CITY OF WEST DES MOINES
CITY COUNCIL MEETING COMMUNICATION

ITEM: Village of Ponderosa Plat 9, Southeast corner of Bluestem Circle and S. Prairie View Drive – Subdivide property into 43 lots for single family development and 4 outlots – Grayhawk Homes of Iowa, Inc. – PP-002800-2015

RESOLUTION: Approval of Preliminary Plat

CITY OF WEST DES MOINES
PLAN AND ZONING COMMISSION COMMUNICATION

VILLAGE OF PONDEROSA PLAT 9
WEST DES MOINES, IOWA
PRELIMINARY PLAT LAYOUT PLAN

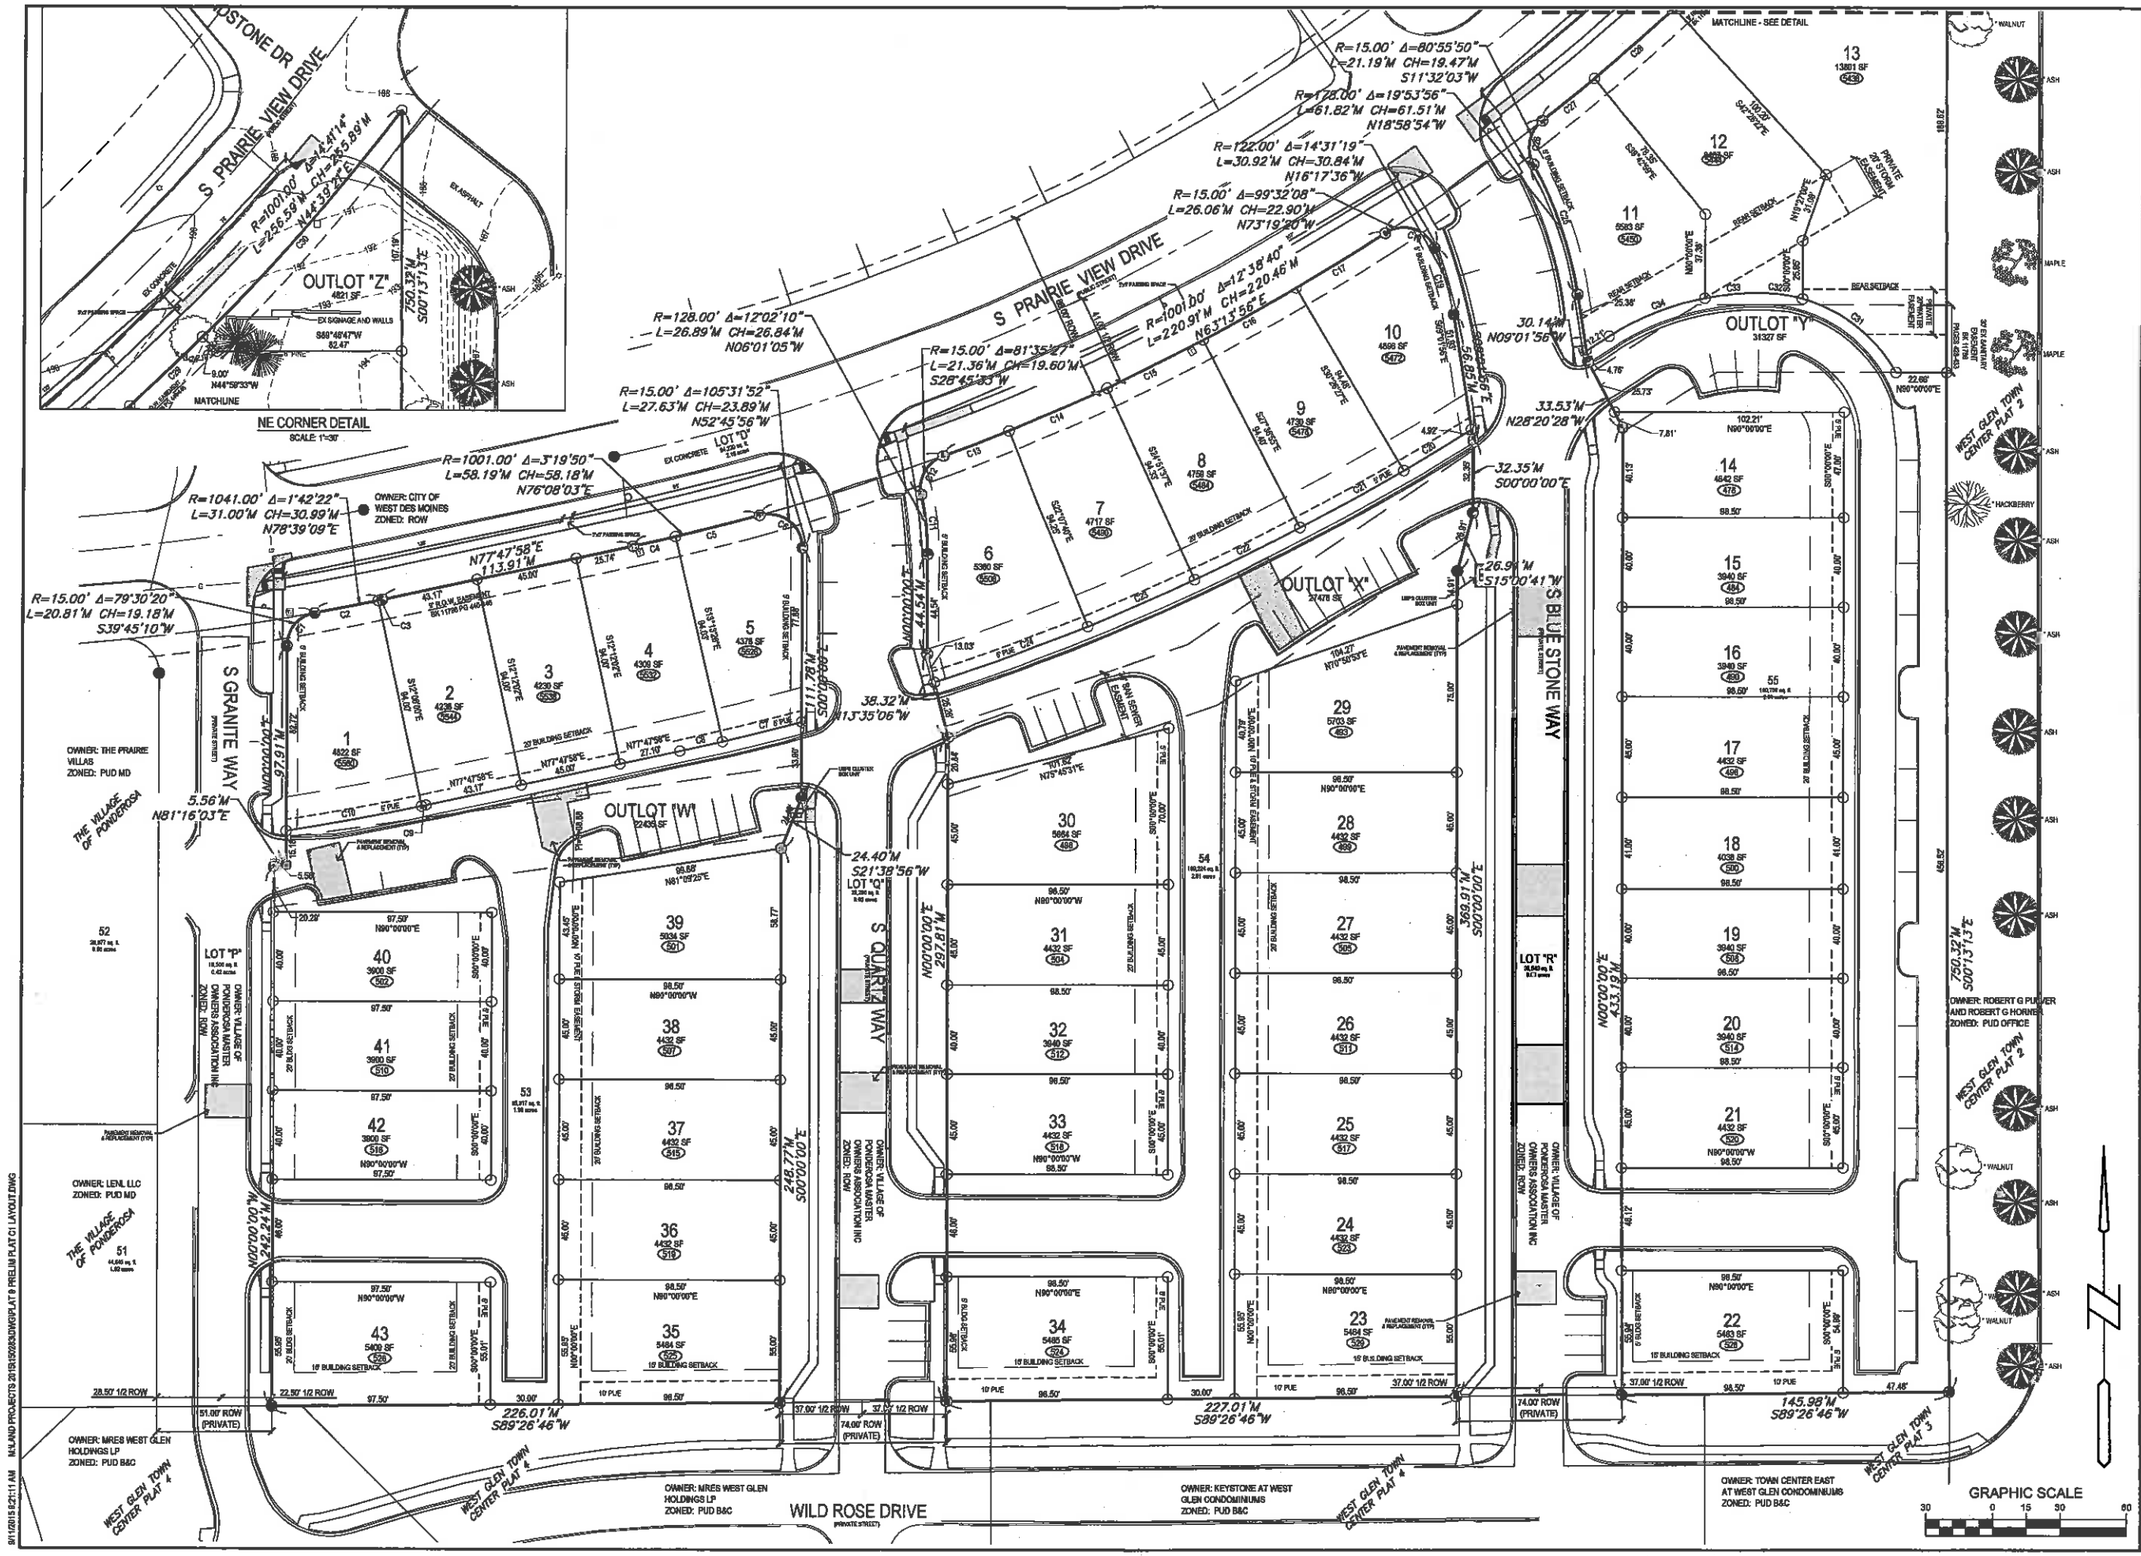
- *Outlots:* The applicant is proposing Outlots W, X, & Y that will contain the private alleys that are already existing on the site. These alleys will be used to access the garages to the proposed single family homes. No driveway access will be permitted to S. Prairie View Drive, S. Granite Way, S. Quartz Way and S. Bluestone Way. These streets will be designated as the front of these homes with the alleys as the rear of the homes. Outlot Z will be designated as open space and will contain the existing Village of Ponderosa entrance sign along with the associated landscaping. The outlots will be maintained by a homeowner's association. In addition, private cross access easements will be dedicated and recorded for Outlots W, X, & Y to allow individual driveway access to each lot across the outlots. Each driveway that connects to the alleys within the outlots will be maintained by the individual property owner, while the alley's themselves will be maintained by the homeowner's association. The homeowner's association documents will be submitted at the time of final plat review.

- *Building setbacks:* Lots 1-13 front onto S. Prairie View Drive. According to the Village of Ponderosa Specific Plan Ordinance, the homes constructed on these lots have a 0' front yard setback. Building overhangs, steps and foundation plantings are allowed to encroach up to 5' into the 9' right-of-way easement along S. Prairie View Drive. The rear yard setback is 20' measured from the back of curb of the private street to allow a vehicle to park in the driveway without hanging over into the street. For Lots 22, 23, 34, 35, and 43, a 15' side yard setback is required to the south along Wild Rose Drive. For Lots 1, 5, 6, 10, & 11, a 5' side yard setback is allowed on the corner as long as the house does not cause a line of sight issue at the intersection.

- *Existing Lots 53, 54, & 55:* Since Lots 53, 54, & 55 are existing lots of record, a building permit could be issued to construct a house on each of these lots prior to the final plat being recorded for the Village of Ponderosa Plat

9. Any homes constructed on these lots prior to final plat approval will be required to meet setback requirements for the lot on which the home is located. A condition of approval is recommended stating such.

4. For any building permit issued prior to approval of the final plat for lots 53, 54, or 55, the building placement and design shall meet all bulk regulations for the future lot being created with Village of Ponderosa Plat 9. It shall be the responsibility of the owner/builder to modify the home, at the owner/builder's expense, if built incorrectly and out of compliance with bulk regulations.
